EXISTING SOUTH ELEVATION

COMPARISON - AS GRANTED SCHEME X EXISTING SCHEME

EXISTING EAST ELEVATION

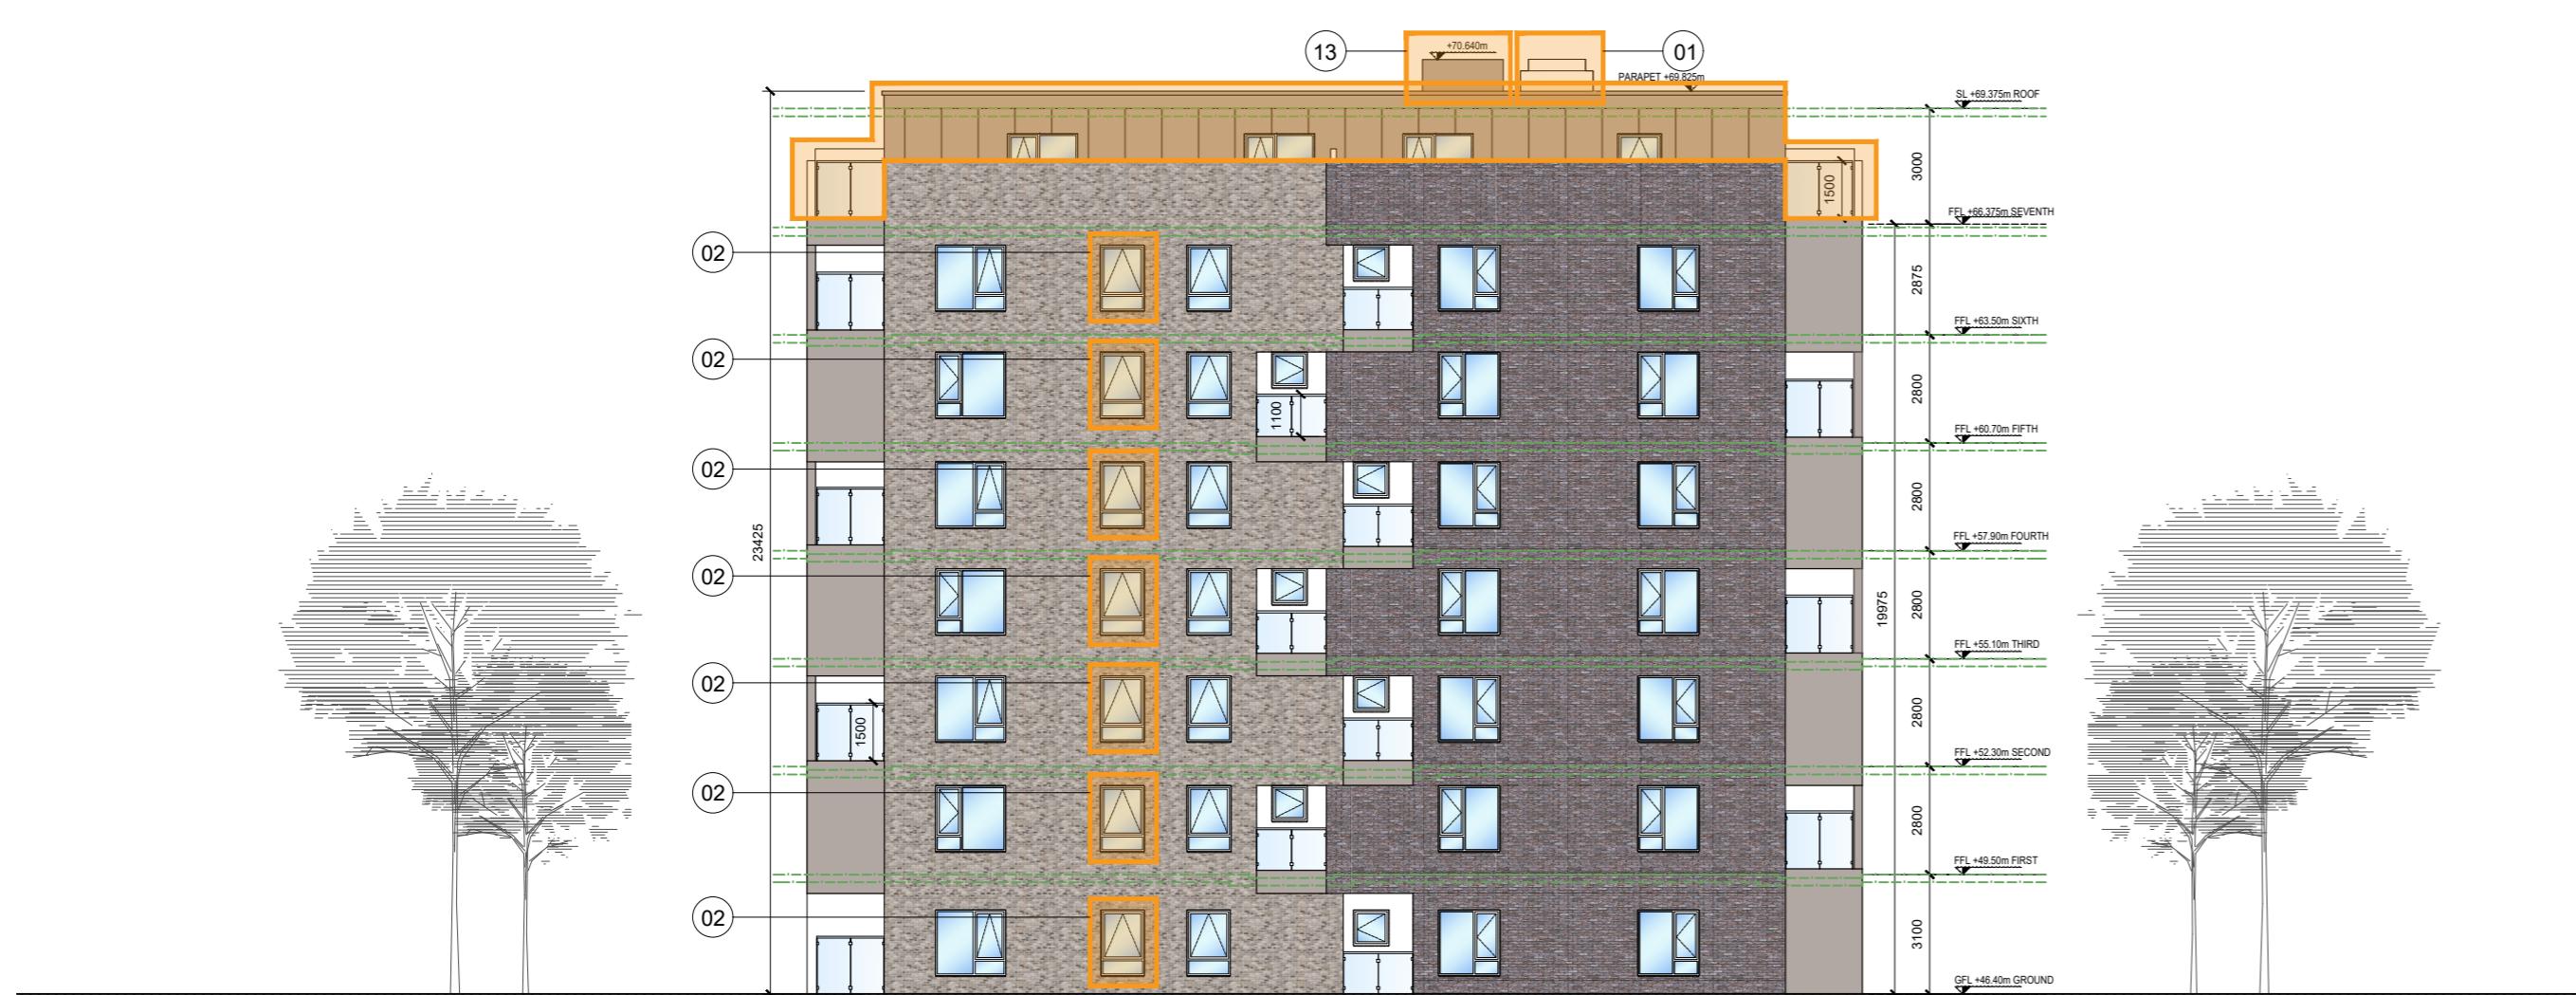
02 - AS GRANTED: PROVISION ONE WINDOW FOR THE LIVING AREA;
EXISTING: A NEW WINDOW WAS BUILT DUE TO A CHANGE IN THE KITCHEN LAYOUT;

03 - AS GRANTED: PROVISION OF A TRIPLE SLIDING DOOR;
EXISTING: A DOUBLE SLIDING DOOR WAS BUILT;

04 - AS GRANTED: PROVISION OF A DOUBLE SLIDING DOOR;
EXISTING: A DOUBLE OPENING WINDOW WAS BUILT;

05 - AS GRANTED: OPENING THE ACCESS DOOR FROM THE RIGHT;
EXISTING: MAIN ACCESS DOOR OPENING CHANGED TO THE LEFT;

06 - AS GRANTED: PROVISION OF A DOUBLE SLIDING DOOR;
EXISTING: A SINGLE OPENING WINDOW WAS BUILT;

07 - AS GRANTED: NO ACCESS TO OPEN SPACE;
EXISTING: A SINGLE DOOR WAS BUILT TO ACCESS THE NEW BALCONY;

08 - AS GRANTED: PROVISION OF A WINDOW;
EXISTING: A DOOR WAS BUILT TO ACCESS THE BALCONY;

09 - AS GRANTED: PROVISION OF A DOUBLE SLIDING DOOR;
EXISTING: A DOUBLE OPENING WINDOW WAS BUILT;

10 - AS GRANTED: PROVISION OF A DOUBLE SLIDING DOOR;
EXISTING: A TRIPLE SLIDING DOOR WAS BUILT INCREASING THE DIMENSIONS OF THE OPENING;

11 - AS GRANTED: PROVISION OF A DOUBLE SLIDING DOOR;
EXISTING: LARGER DOUBLE SLIDING DOOR WAS BUILT;

12 - AS GRANTED: PROVISION OF WINDOW AND DOOR OPENINGS FOR A PENTHOUSE LAYOUT FOR 3 No. 2-BEDS UNITS AND 4 No. 1-BED UNITS;
EXISTING: LAYOUT HAS BEEN RECONFIGURED TO A PENTHOUSE WITH 1 No. 2-BEDS UNIT AND 6 No. 1-BED UNITS SO ALL THE WINDOW AND DOOR OPENINGS WERE BUILT IN DIFFERENT POSITIONS OR DIMENSIONS;

13 - AS GRANTED: THE PREVIOUSLY APPROVED LIFT DIDN'T INCLUDE AN ENGINE ROOM;
EXISTING: THE LIFT ENGINE ROOM WAS BUILT ACCORDING TO THE MANUFACTURER'S SPECIFICATIONS, CHANGING THE DESIGN SEEN IN THE ROOF PLAN AND ELEVATION;

14 - AS GRANTED: PROVISION OF A DOUBLE SLIDING DOOR;
EXISTING: A TRIPLE OPENING WINDOW WAS BUILT;

15 - AS GRANTED: PROVISION OF A DOUBLE SLIDING DOOR;
EXISTING: A TRIPLE SLIDING DOOR WAS BUILT;

16 - AS GRANTED: PROVISION OF A DOUBLE WINDOW;
EXISTING: A TRIPLE OPENING WINDOW WAS BUILT;
